MFN 06-274

Subject: Response to RAI Letter Number 20 Related to ESBWR Design Certification Application – Seismic Design – RAI Numbers 3.7-16, 3.7-24, 3.7-27, 3.7-30, 3.7-32, 3.7-33, 3.7-35, 3.7-37, 3.7-38, 3.7-39, 3.7-50, 3.7-54 and 3.7-57

**Response to NRC RAI Letter No. 20 Related to ESBWR Design
Certification Application**

Shimizu Engineering Report																	
Project	General Electric Company ESBWR Project		Shimizu Document No.	SER-ESB-033													
Title	Parametric Evaluation of Effects on SSI Response		Rev.	0													
			Issued Date	8/14/06													
			Revised Date														
<p>NOTE:</p> <p>This document provides additional SSI analyses performed and results obtained for the Reactor/Fuel Building Complex (RBFB) the Control Building (CB) to address the following issues identified in RAIs.</p>

Figure 7.5-1 Floor Response Spectra - RBFB Basemat X

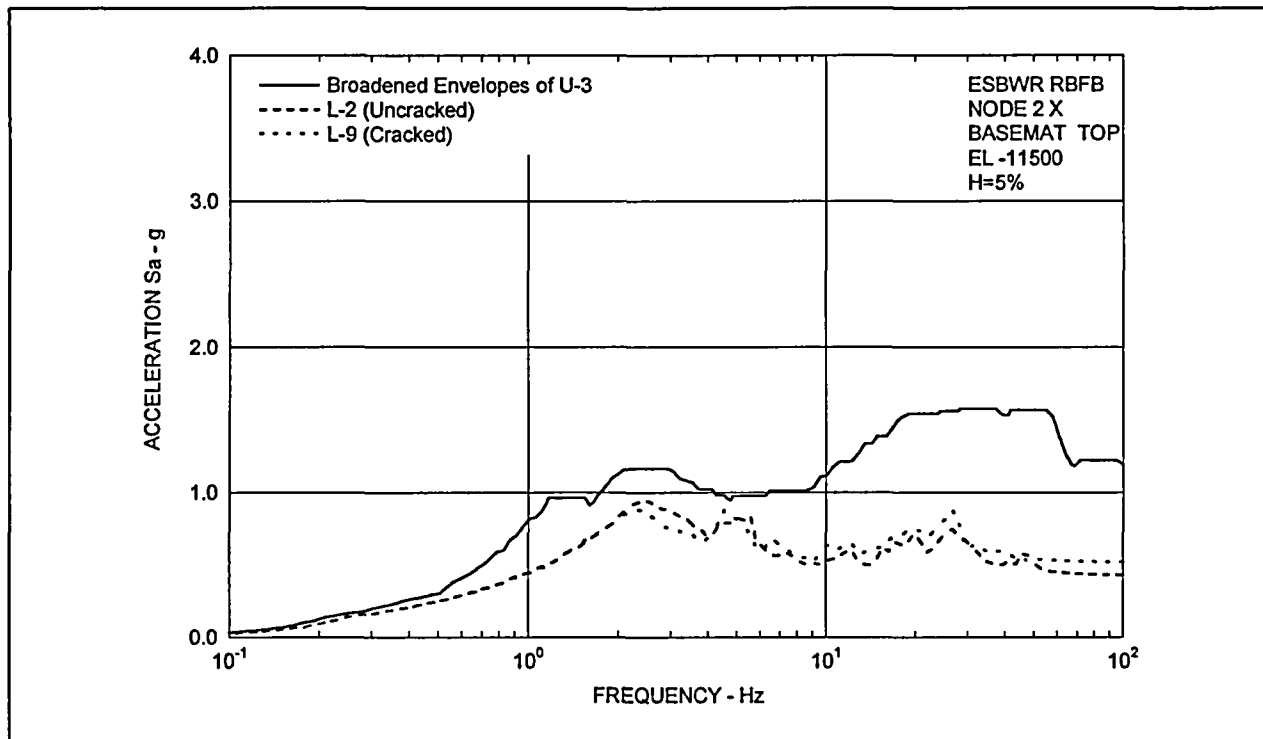
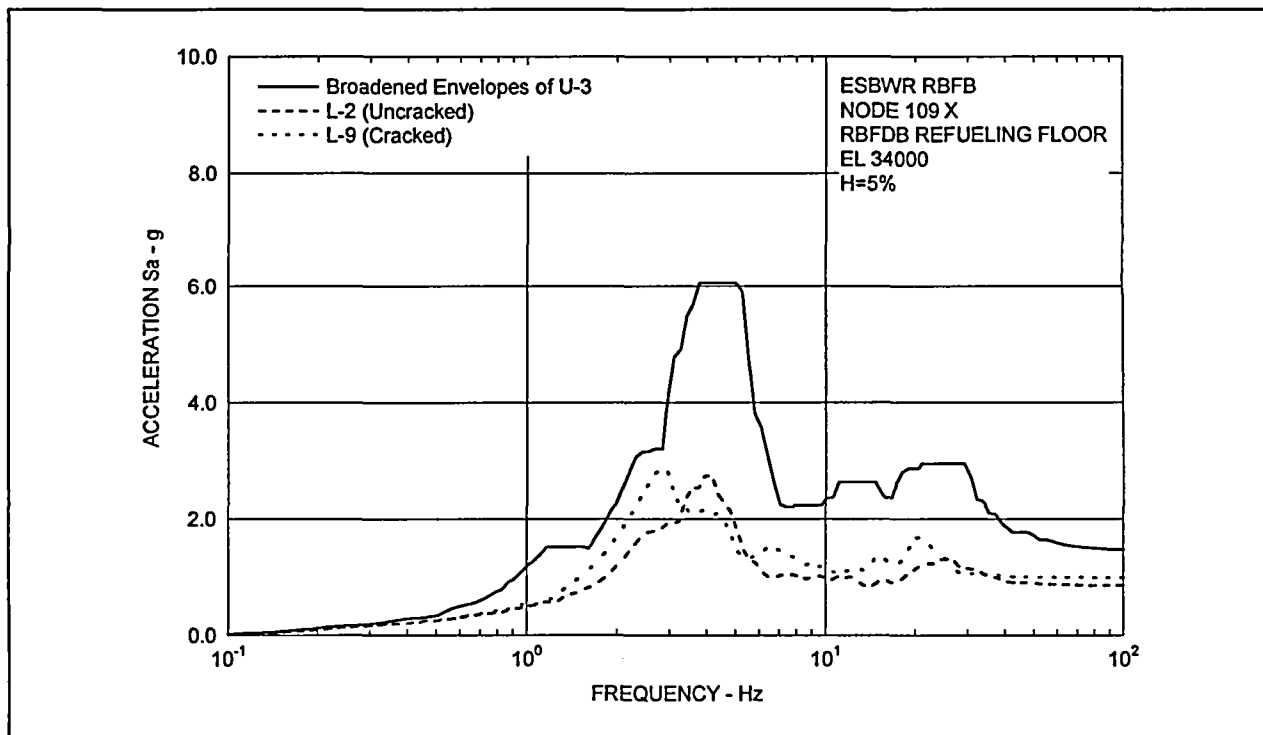
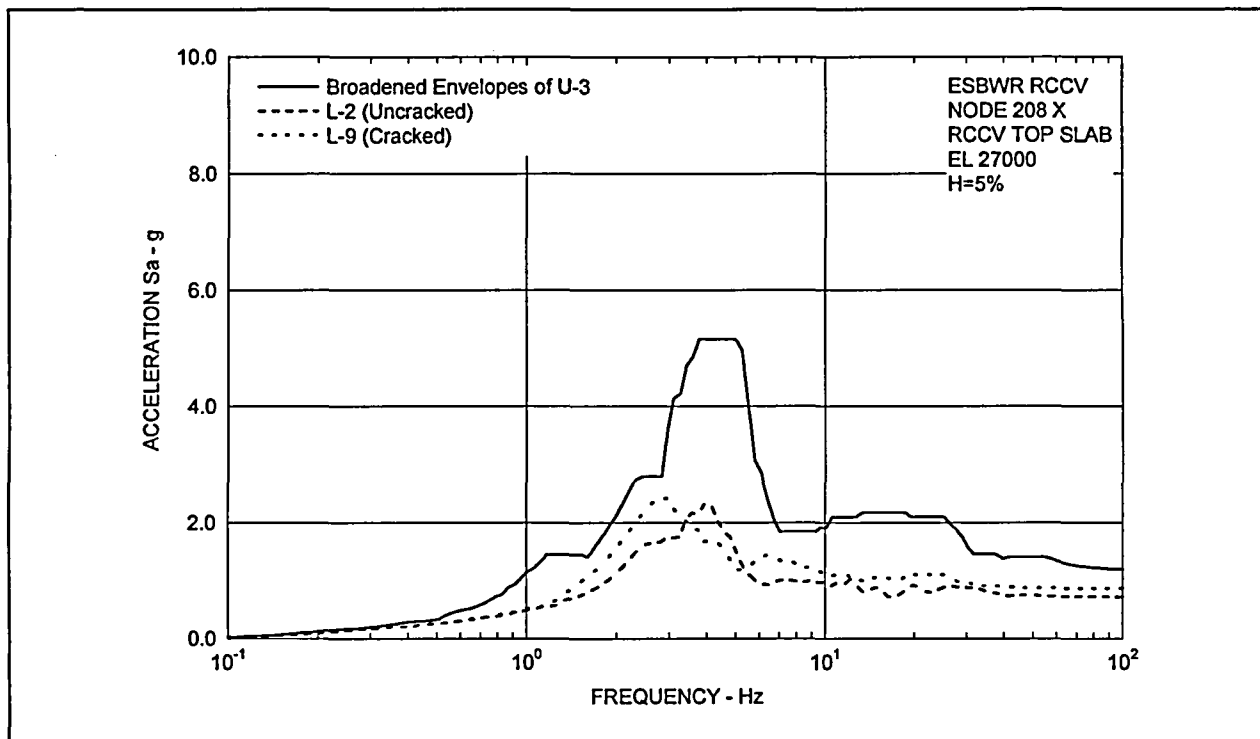
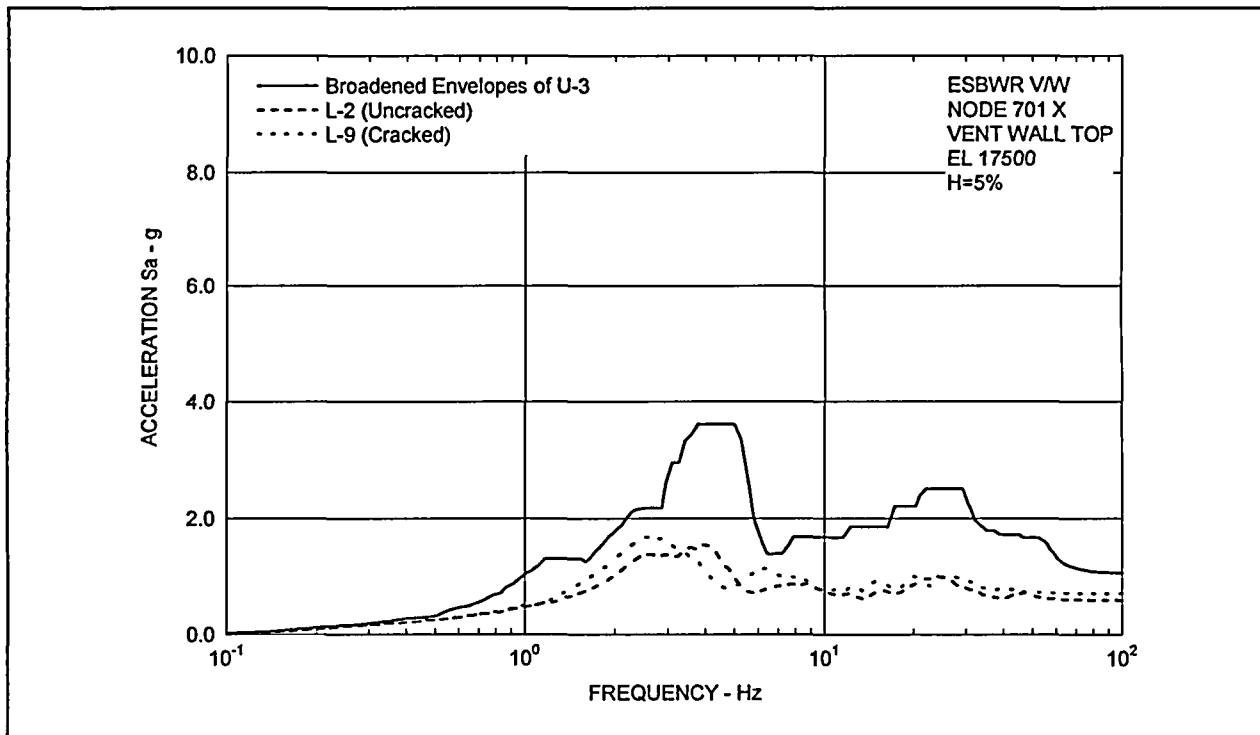
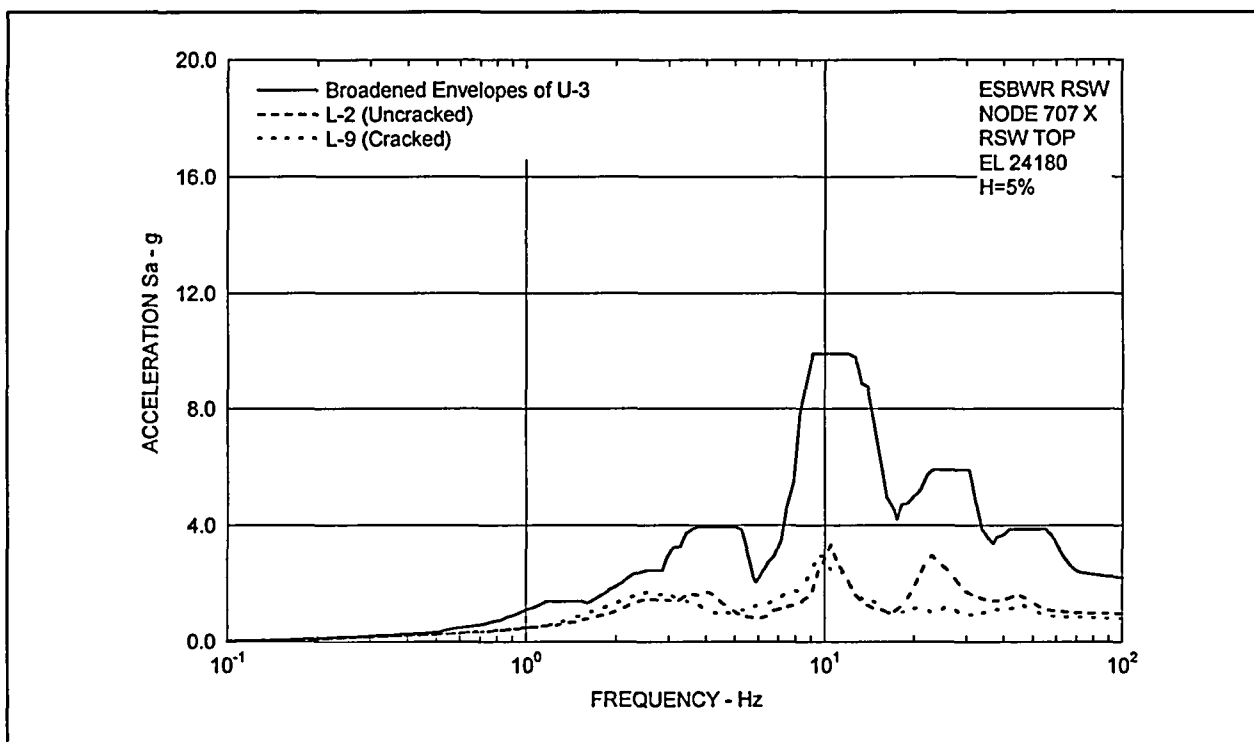
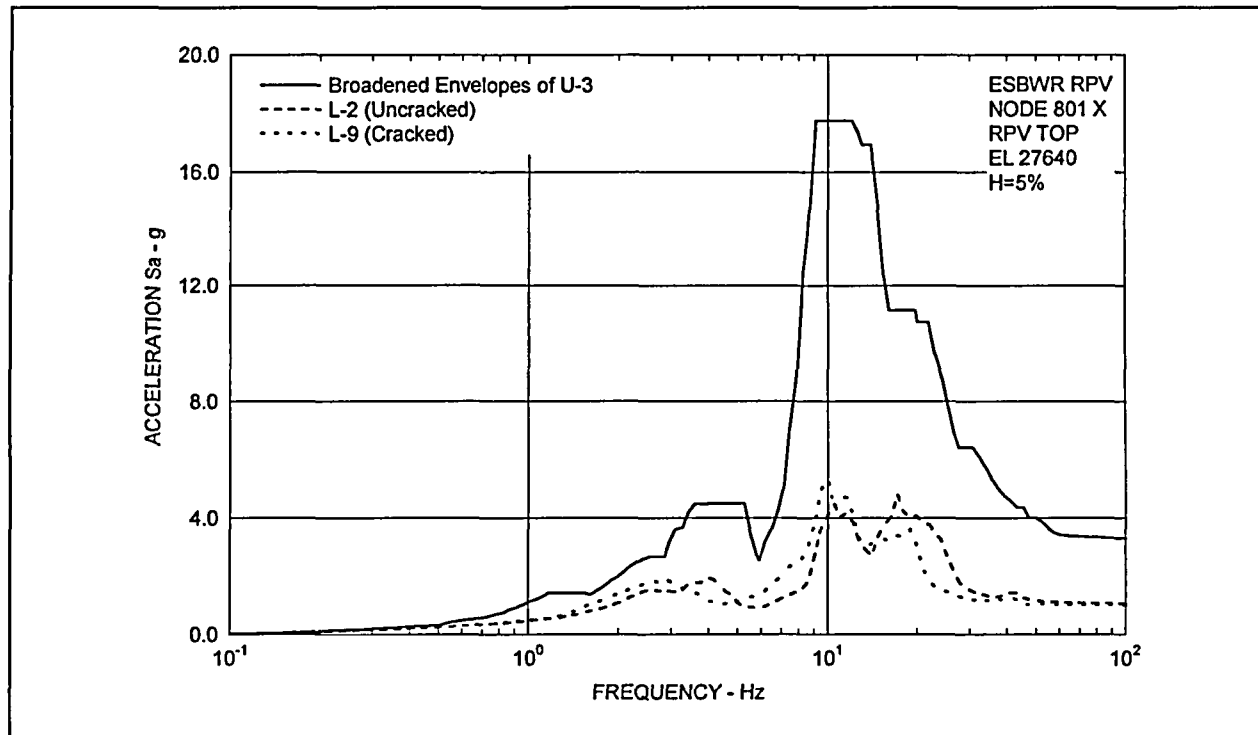
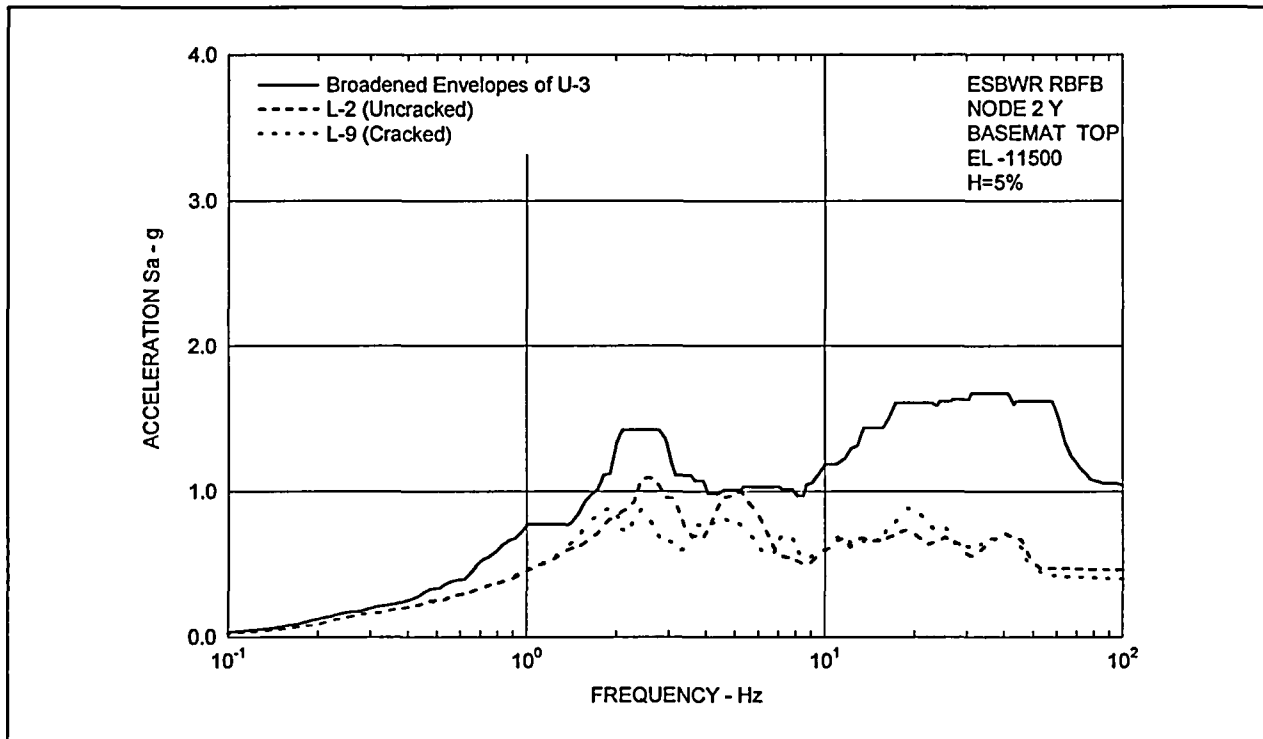
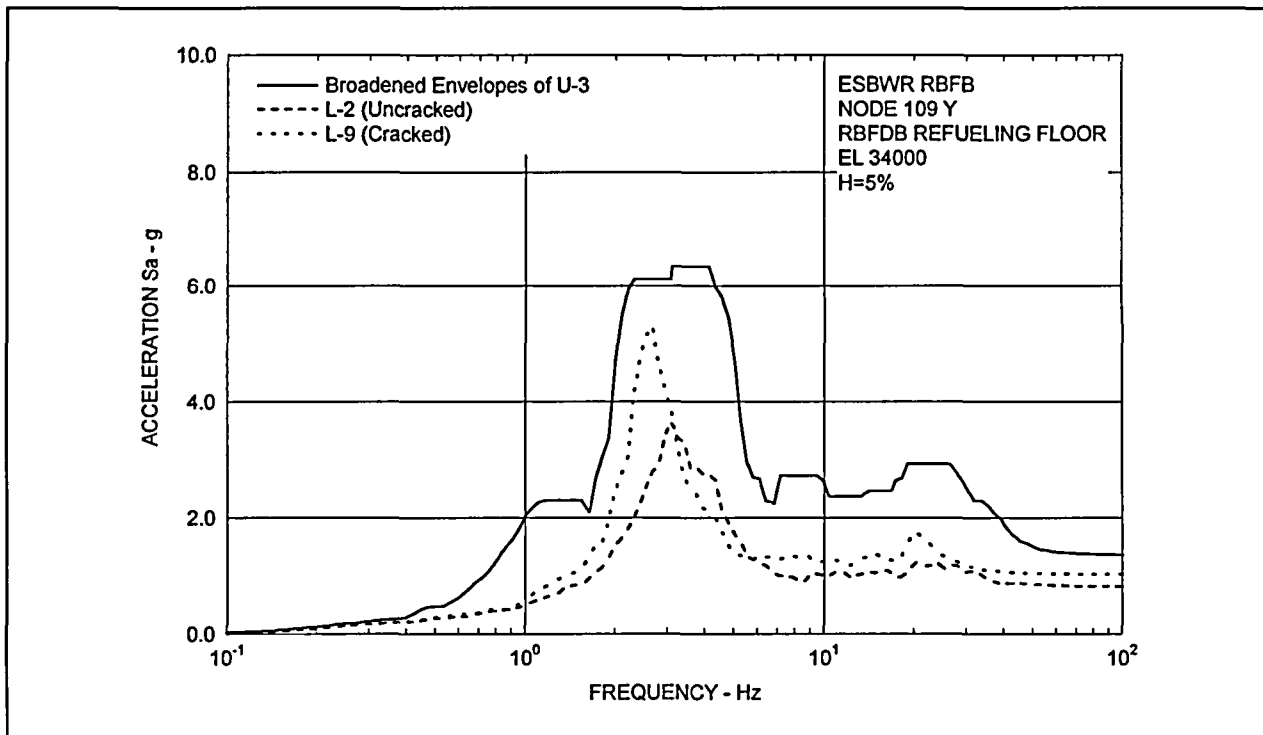
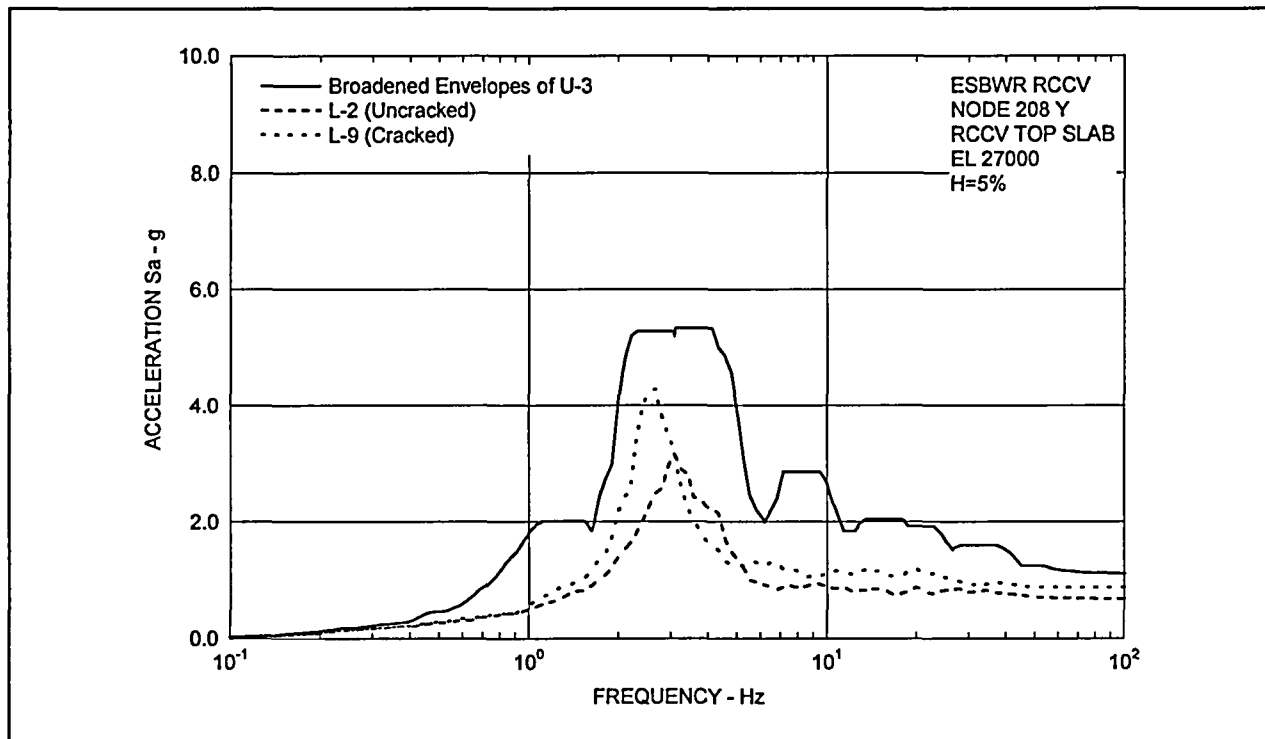
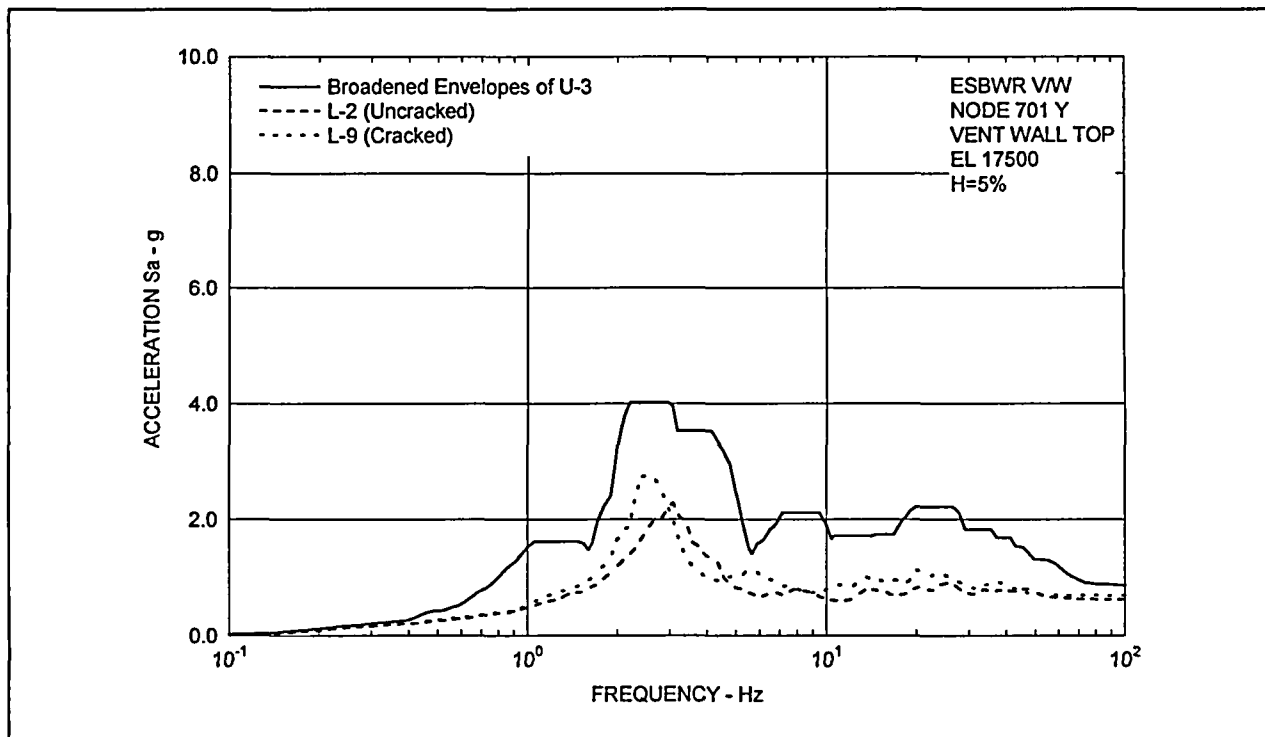
DCD Section 3.7.2.3, "Procedures Used for Analytical Modeling," does not address the method used to develop stiffness values (uncracked concrete sections versus cracked concrete sections) for concrete structural elements for the seismic analysis models. The staff requests the applicant include in the DCD a detailed description of the method applied to determine the stiffness values for both cracked concrete sections and uncracked concrete sections in the seismic analysis models.

Comparisons of floor response spectra (FRS) (5% damping) at selected RBFB locations are shown in Figures 7.5-1 through 7.5-12. The broadened envelope results of Case U-3 (uniform site, single envelope input motion case) are also shown in the figures for comparison.

It is found from the results that the FRS peaks move to lower frequencies by concrete cracking; however, both FRSs of uncracked and cracked cases are bounded by the broadened envelope responses of uniform site cases in the whole frequency range.

As stated in Section 7.1, the existing DCD design load will be updated to incorporate the responses due to the single envelope input motion at the uniform sites. The revised DCD design load has no impact from the effect of concrete cracking.
